*Southern California Edison*  
**Presidential Substation Project A.08-12-023**

**DATA REQUEST SET Presidential ED-05**

**To:** ENERGY DIVISION  
**Prepared by:** Steve K. Alford  
**Title:** Manager - TPD-L&E  
**Dated:** 11/22/2010

**Figure CD-4: Typical Conduit Bank Sections (Mainline and Commercial/Industrial)**

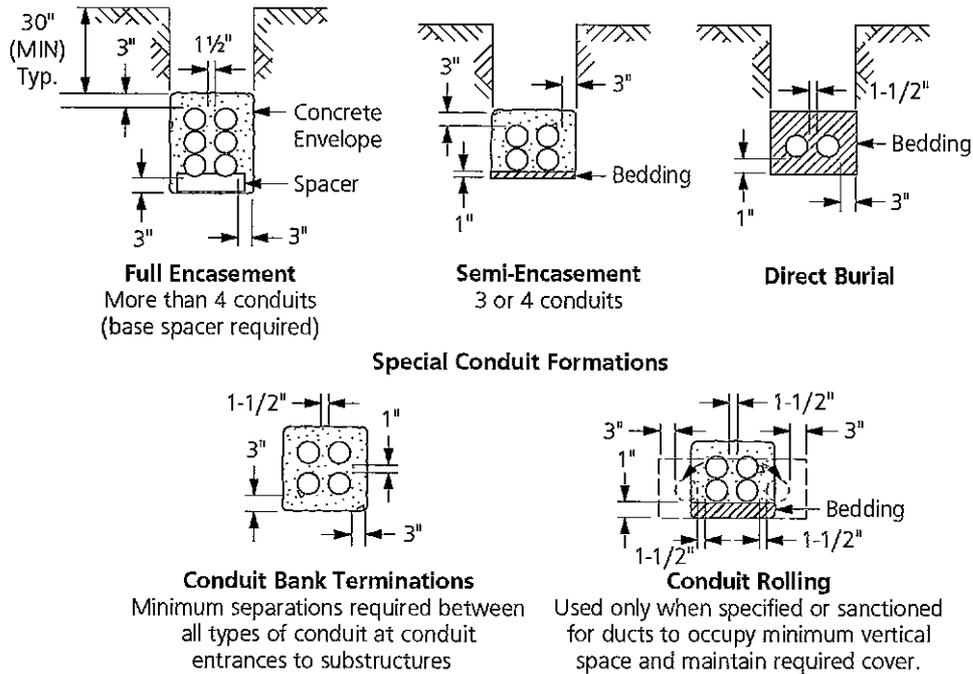
In general, describe the requirements/feasibility for undergrounding both the 66 kV and 16kV underground

- Trench depth and width
- What is the separation distance required between the two and would it require two separate trenches or just one.
- Trenching methodology
- General installation requirements
- Tree removal requirements (what are the requirements that trigger tree removal?)
- Would the telecommunication lines be located underground with the subtransmission and distribution lines? If not describe the facilities necessary for installing the telecommunications lines.
- Describe any preliminarily known feasibility constraints.

The civil construction work required to install the 16 kV distribution underground substructure of four 5-inch conduits in a concrete semi-encased duct bank would typically involve using a backhoe with a 24-inch bucket to excavate an approximate 24-inch trench approximately 45 inches deep. Shields or trench shoring may then be temporarily installed for safety to brace the walls of the trench. Four 5-inch conduits would then be installed using spacers to create a duct bank consisting of two columns of two stacked 5-inch conduits apiece. Any temporary shoring would be removed. The conduits would then be semi-encased in concrete with a minimum encasement of 3 inches on all sides except the bottom. After the concrete encasement has hardened, the trench would be backfilled with 1.5 sack sand slurry (which is a mix of sand and water with 1.5 bags of cement added with no aggregate per yard) in accordance with the minimum permit requirements as required by the local jurisdiction (e.g. the city) in which the trench is located. Later, the job would be finished as the street would be repaved in accordance with the city's permit requirements.

Please refer to the attached page (CD 120) from SCE's Distribution Underground Construction Standards to see the conduit bank requirements for

typical duct bank block diagrams.
